**SUBJECT: SUBMITTAL OF FINAL "SITE INVESTIGATION WORKPLAN, DEL VALLE
WATER TREATMENT PLANT, LIVERMORE"**

**PROPOSED SITE
ASSESSMENT WORKPLAN**

**ZONE 7 WATER AGENCY
DEL VALLE WATER TREATMENT PLANT
601 EAST VALLECITOS ROAD
Livermore, California
STID 4138**

FIGURE 2

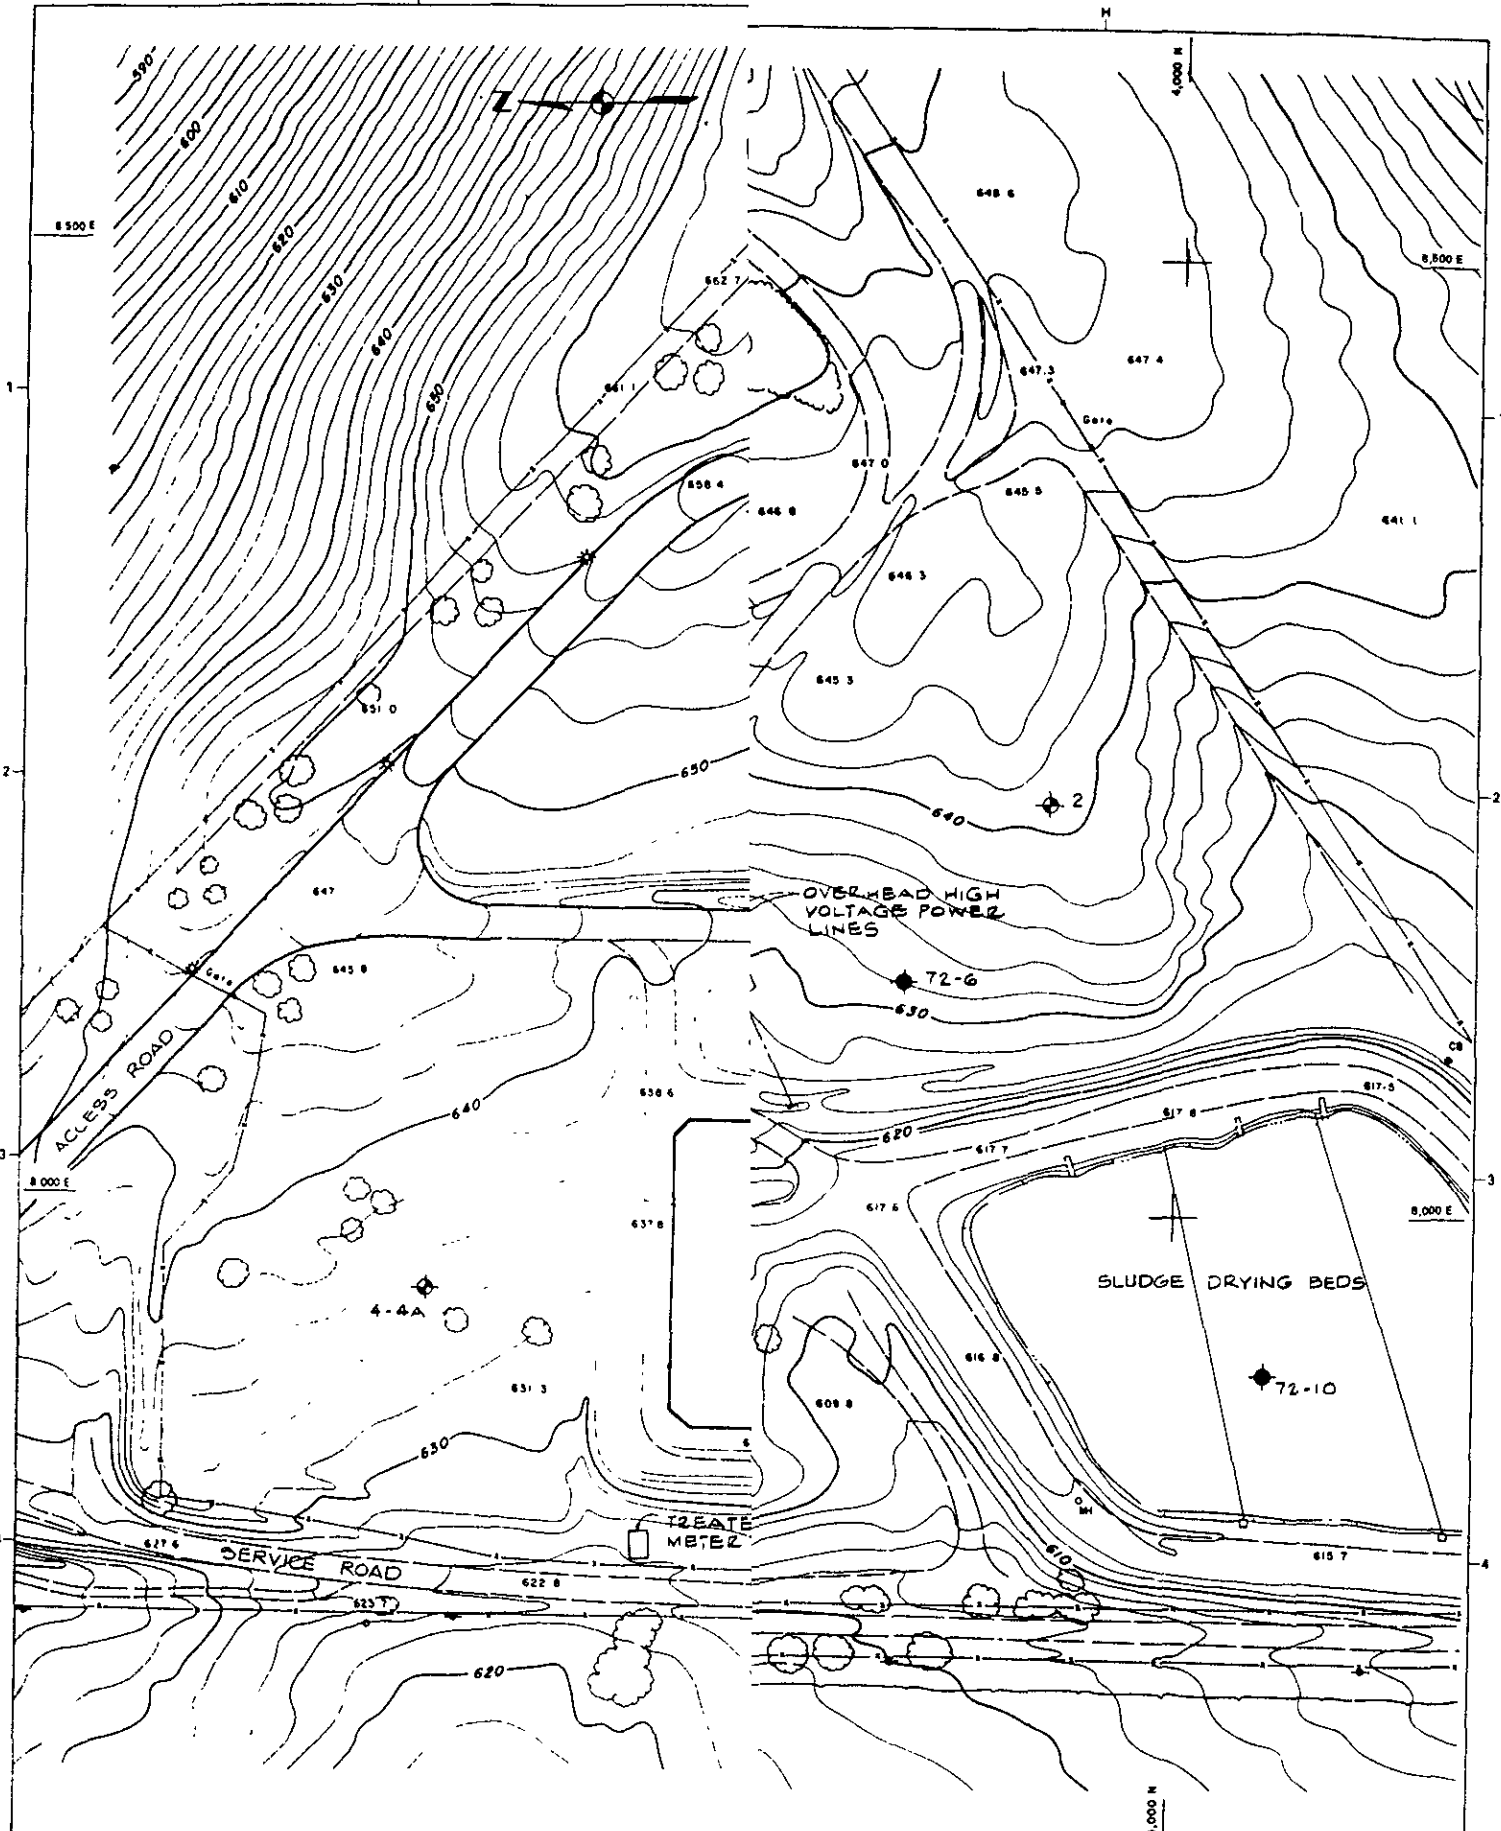
It is proposed to collect a groundwater sample from existing de-watering well 1+00. The location of de-watering well 1+00 is indicated on Figure 2. *Not necessary - too far away.*

FIGURE 5

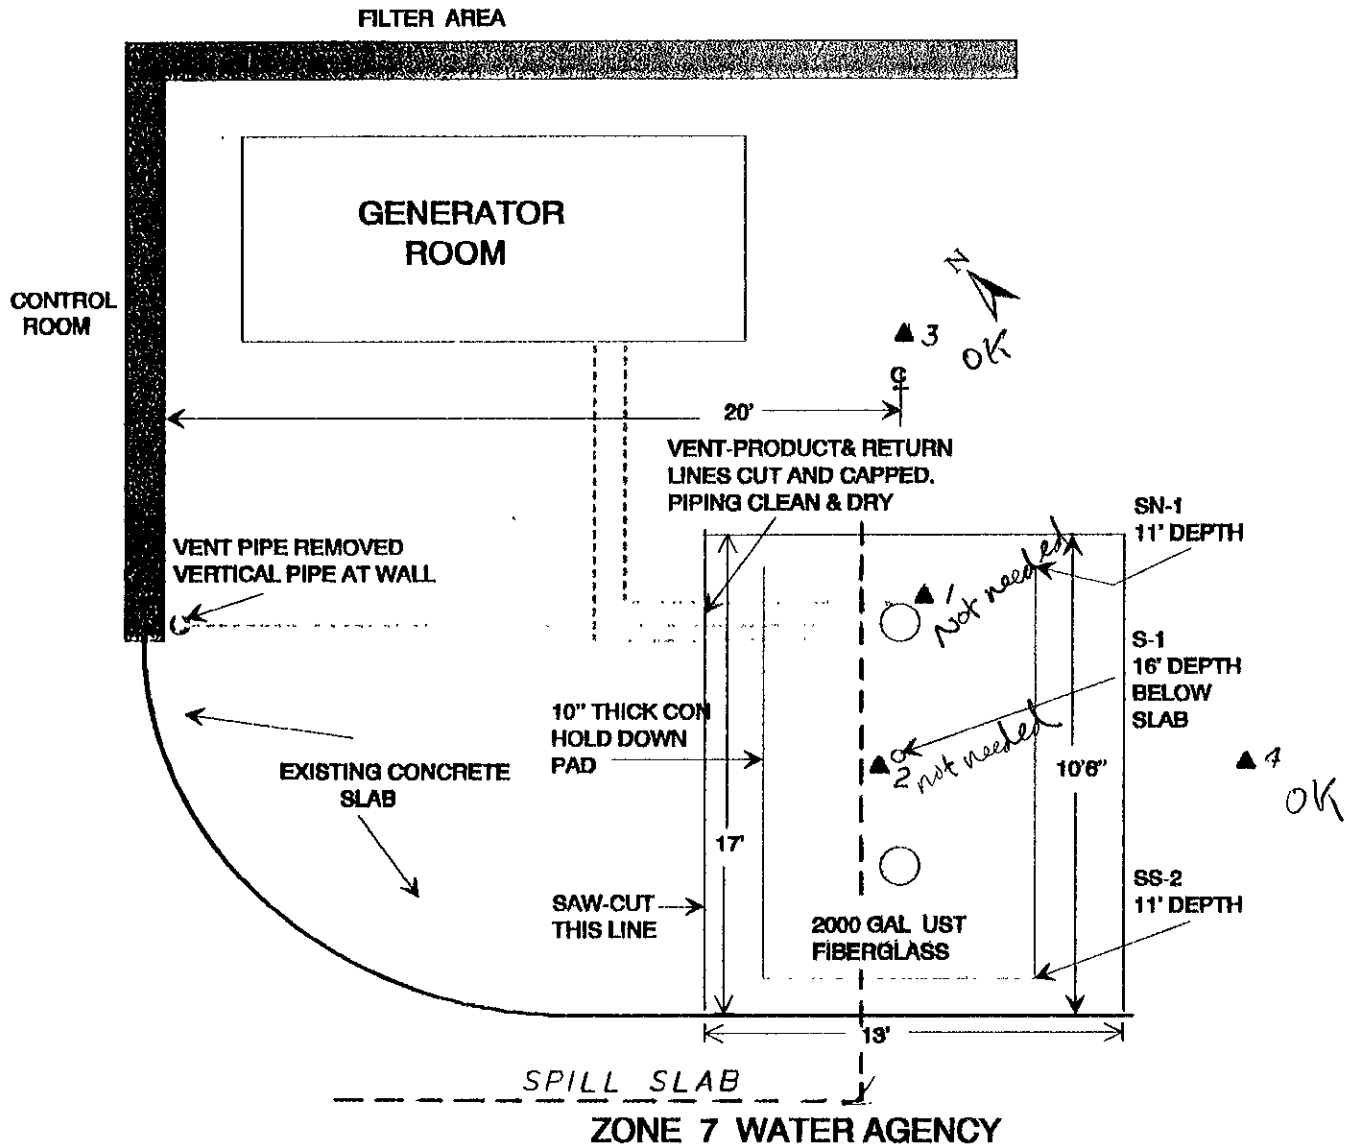
should be: north end south end south end

Due to the presence of the spill containment slab constructed for the new above ground fuel tank, it will be necessary to drill proposed boring No. 2 on a slant. Proposed borings No. 1, 3, 4 and 5 will be vertical. *→ Not needed*

want down gradient borings for this
Boring ① will be eventually advanced until encountering groundwater, auger refusal or completing 20 feet of apparently clean hole below the last observed contamination. A final soil sample will be collected from the hole bottom.

not needed

Borings 3, 4 and 5 will be sited 5 feet laterally from the east, south and north sides of the former tank excavation. Borings 3, 4 and 5 will be drilled entirely through native soil, consequently it is proposed to collect soil samples at 5 foot intervals. If obvious soil contamination is encountered in any boring, the boring will be continuously sampled until the absence of apparent contamination is observed. Borings 3, 4 and 5 will be advanced to a depth of 20 feet BGS if no apparent contamination is encountered. If soil contamination is observed, the boring will be advanced at least 5 feet beyond the absence of apparent contamination. *Boring 5 to be advanced (continuous core) to 50' to verify DTW. GW grab sample to be collected if encountered.*

All soil samples will be sealed, labeled, chilled and entered on a chain of custody form as specified in the appendix section: SOIL BORINGS AND SAMPLING. Soil samples will be hand carried to a DHS certified laboratory for analytical testing. Each sample will be discreetly analyzed for TPH-diesel and BTXE by EPA method 8260, GC/MS. *Soil w/ obvious contamination should be analyzed for PNAs*
